DRB Application No.: 11DRB-70252 , Project # 1005354
Project Name: ARBOLEA DE VIDA + SAUNDYLL VILLAGE UNIT 2B
Agent: DEKKER PERICH SABATINI Phone No.:

DRB Application No.: <i>11DRB- 70265</i>	Project # <i>1005354</i>
Project Name: <i>Arbolera De Vida Unit 2B. Sawmill Village</i>	
Agent: <i>Dekker Perich Sabatini</i>	Phone No.:

**Re: Reason for Request
Sawmill Village
Request for Amended Site Development Plan for Subdivision
Tract 2-D of the Arbolera de Vida Subdivision, Albuquerque, NM (Phase 2)
Project # 1005354; 07EPC-00109**

11DRB-70265 MAJOR – SITE DEVELOPMENT PLAN FOR BUILDING PERMIT

DEVELOPMENT DESIGN STANDARDS CONTENT GRAPHIC
 SHEET NO. **SDP3**
 3 OF 4

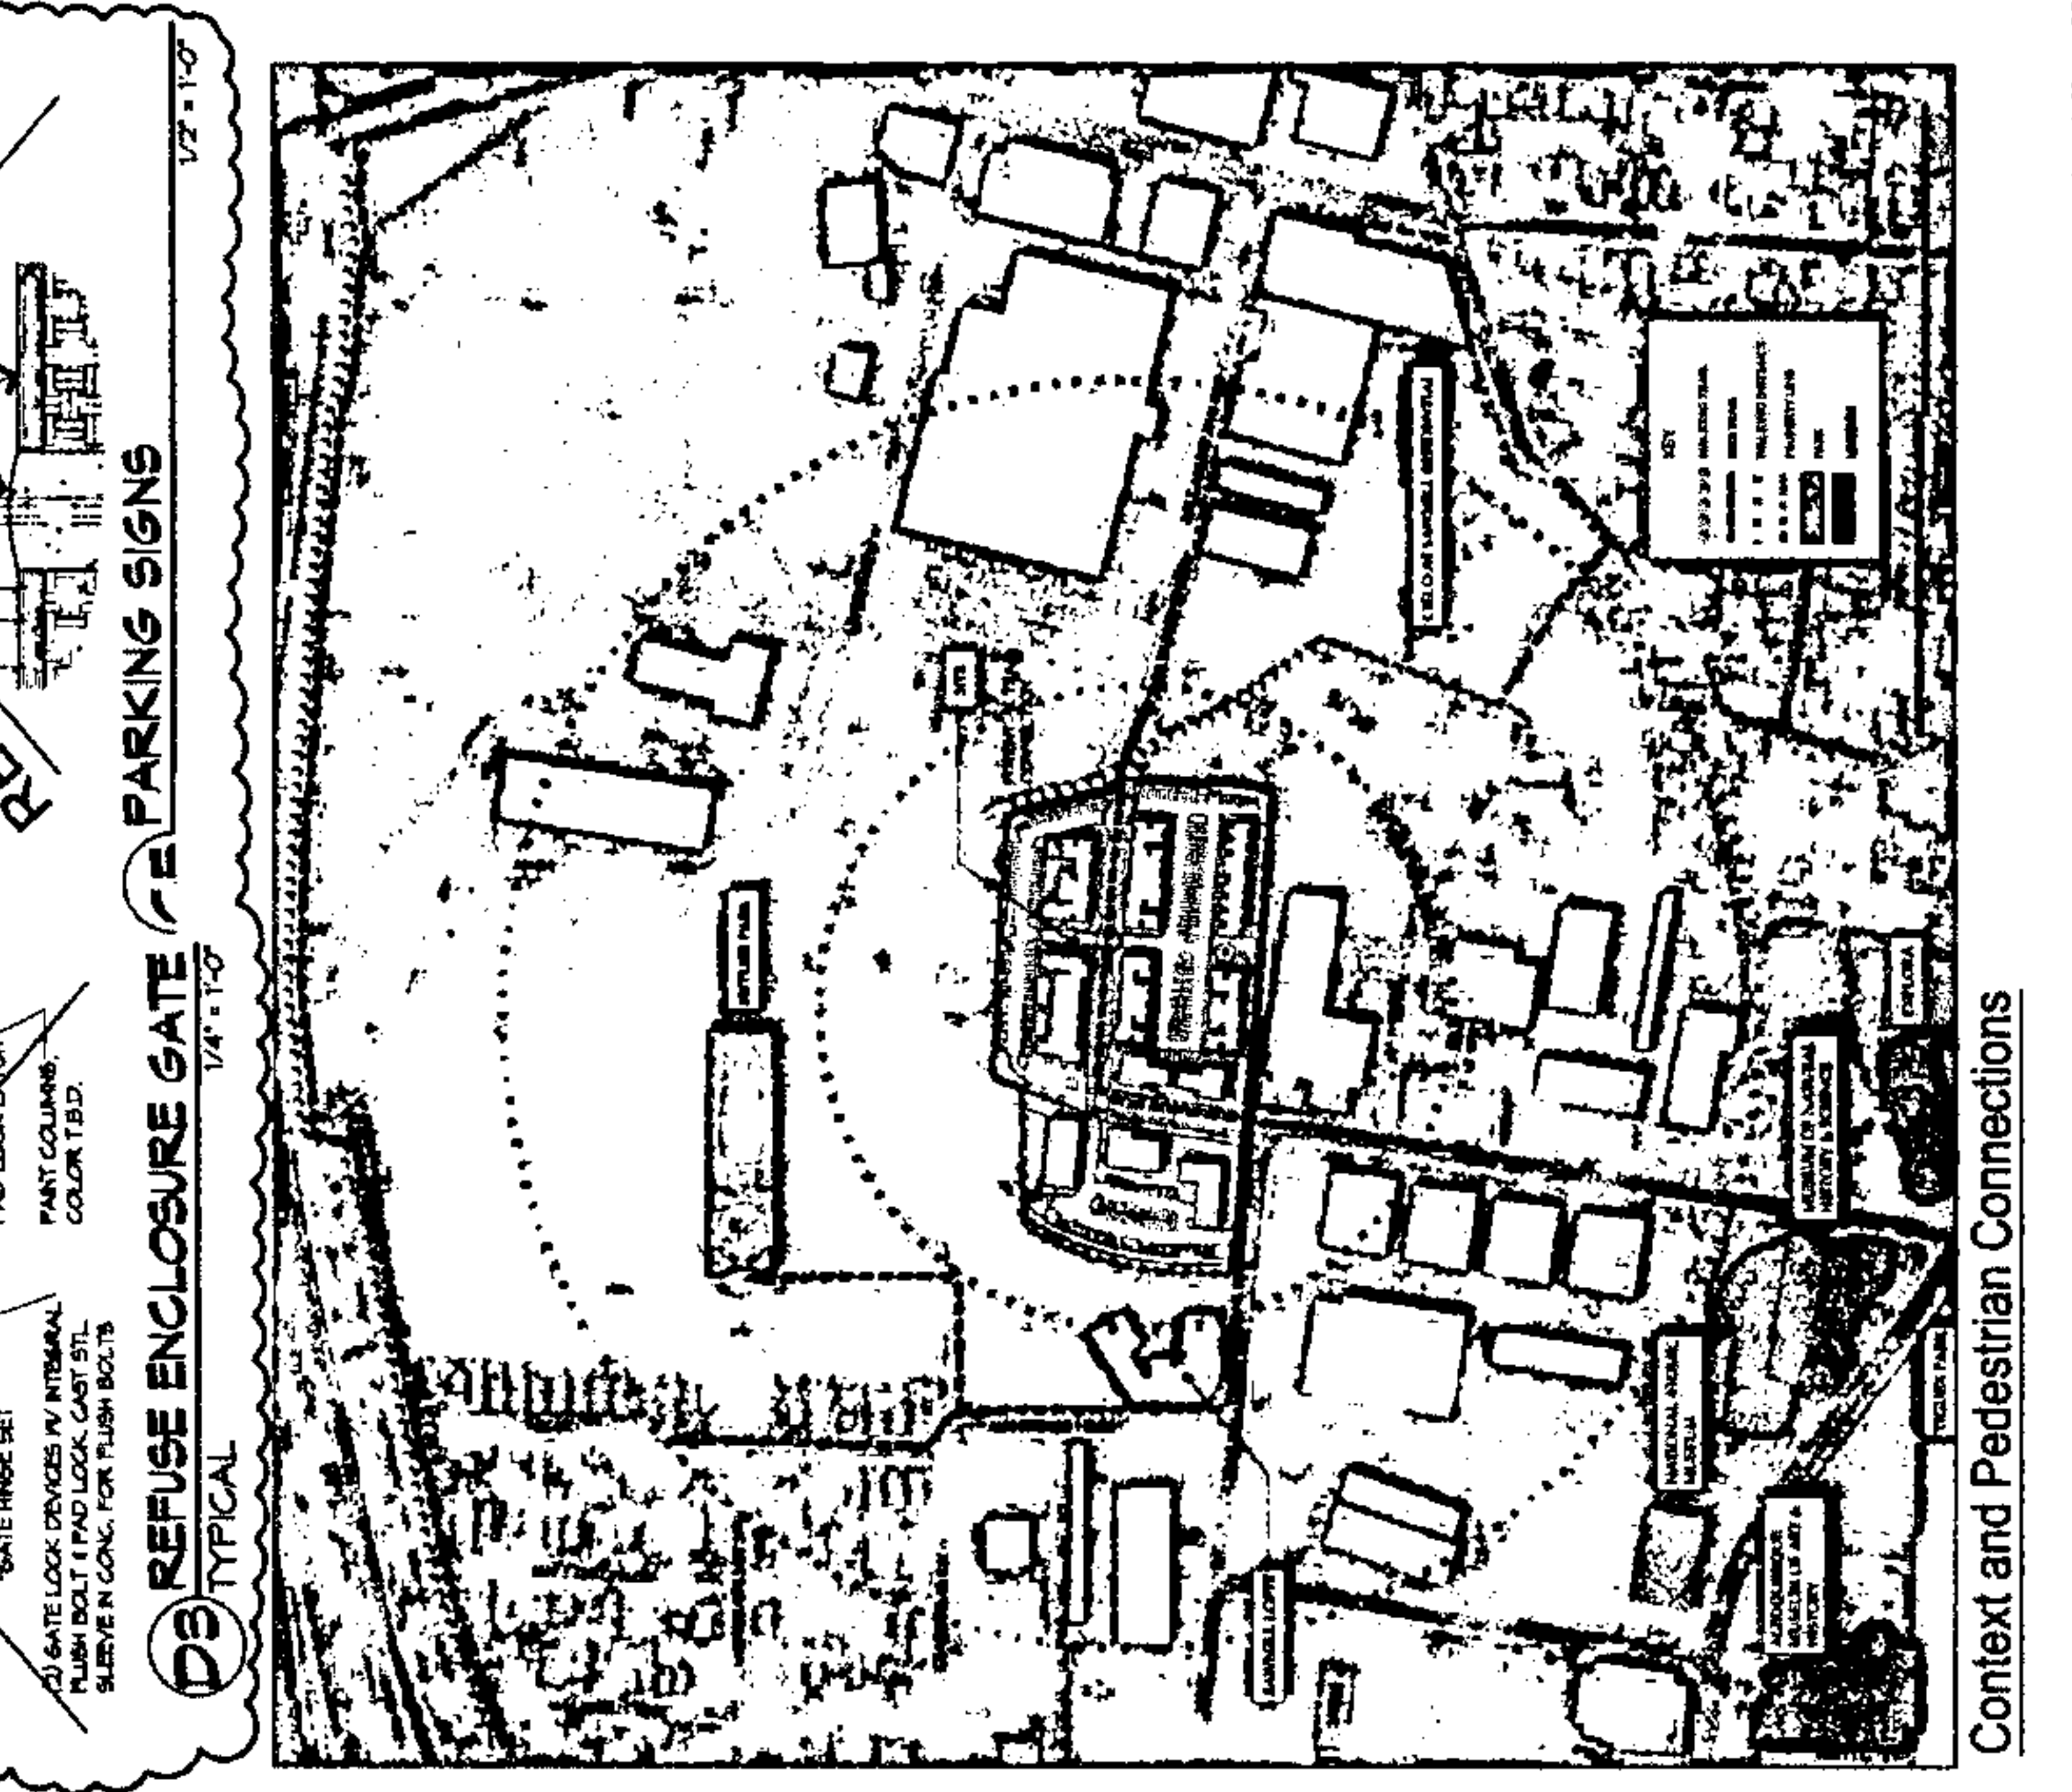
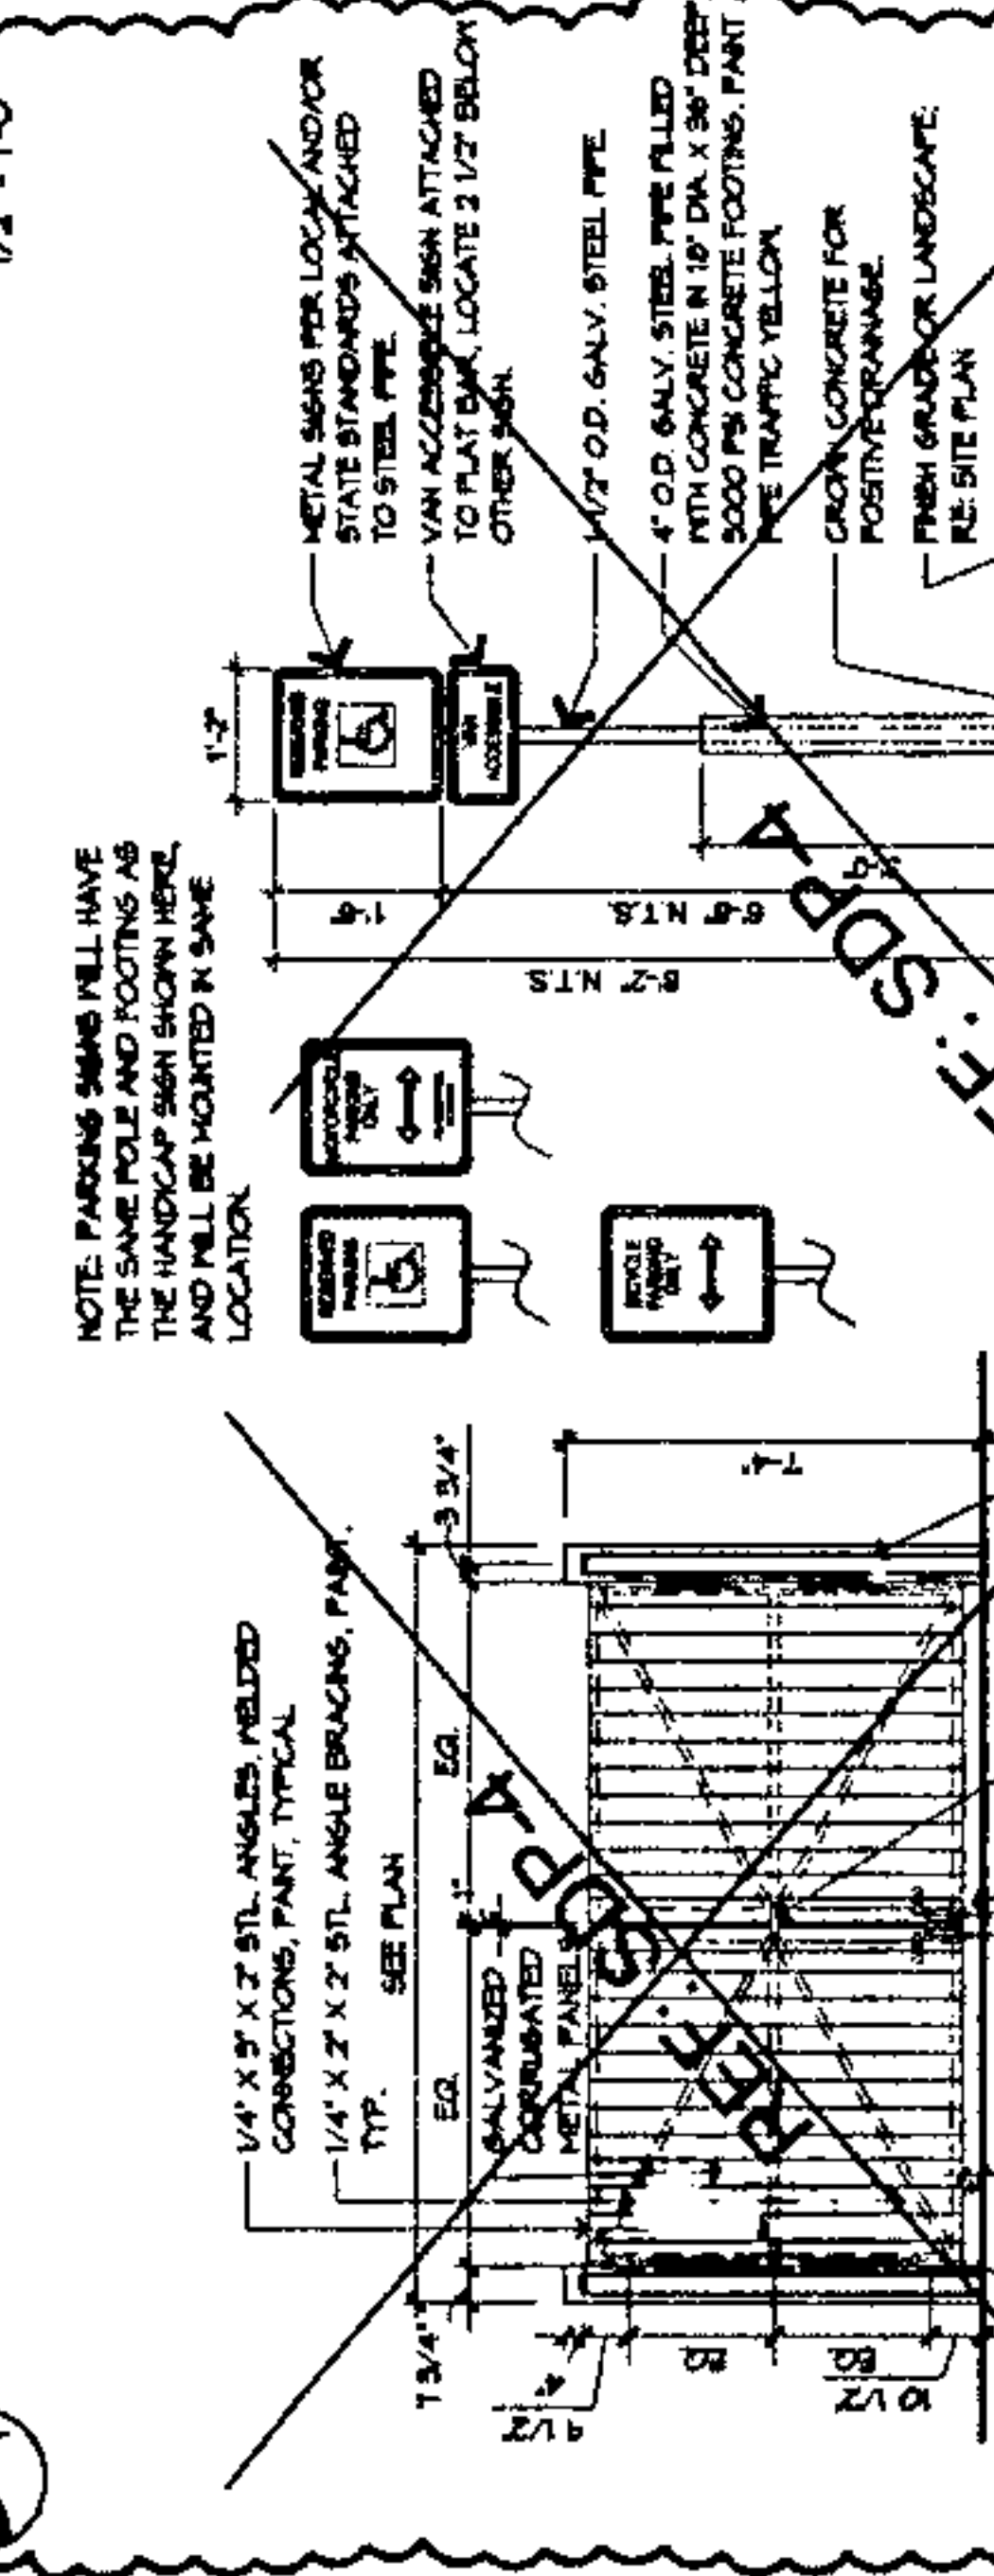
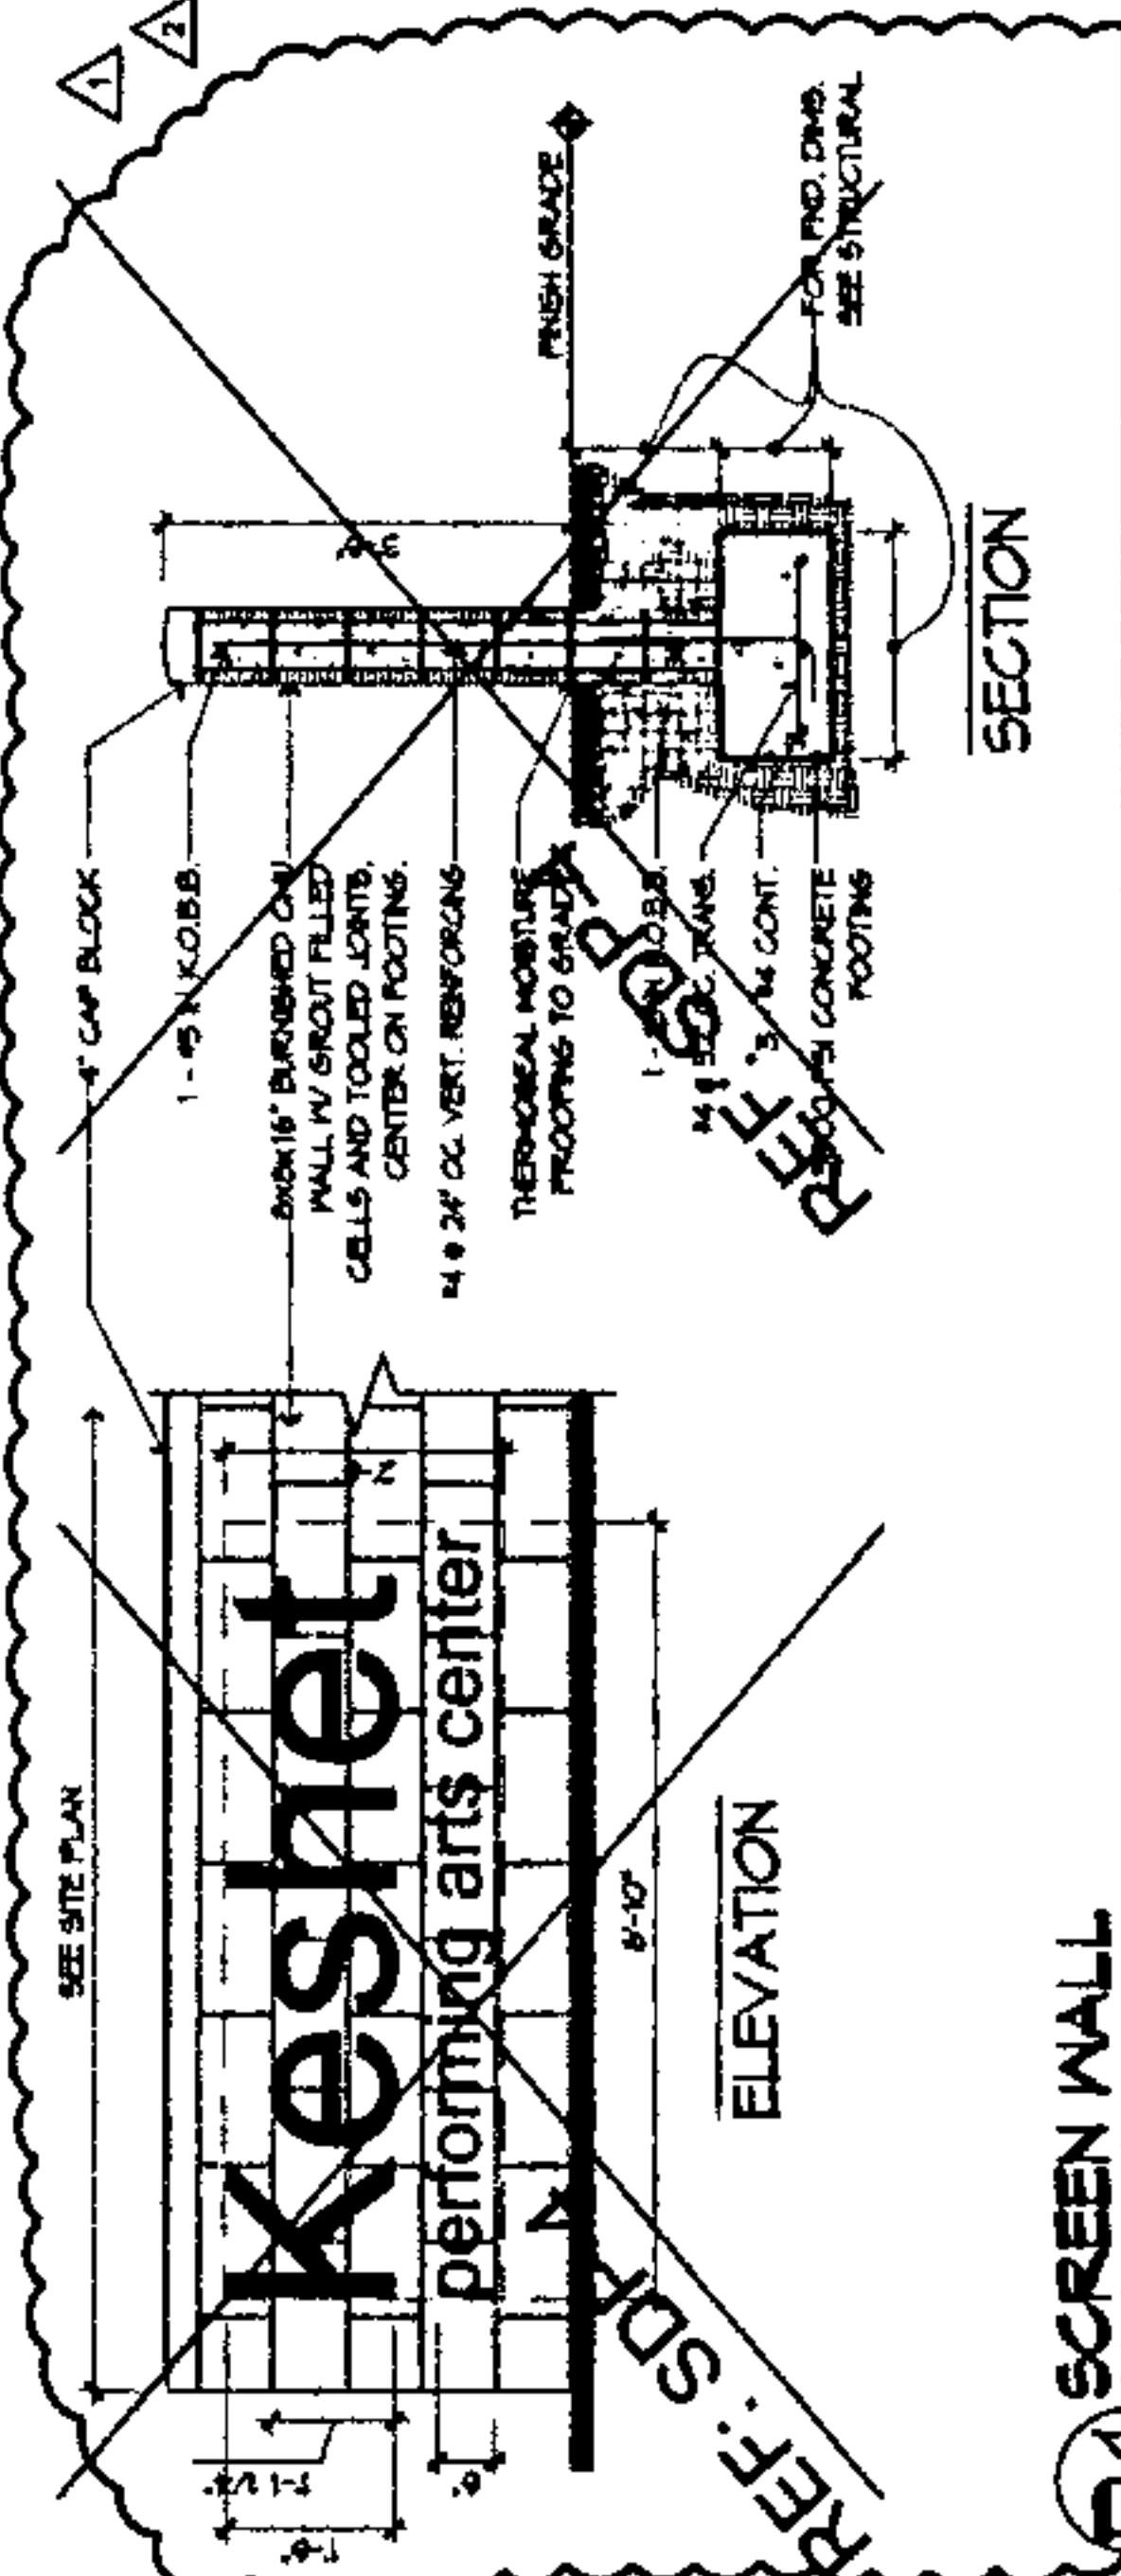
12. **CONDITION:** Reflective glass shall not be permitted (General SU-2 regulation 4.f.).

RESPONSE: A note has been added to sheet SDP3.
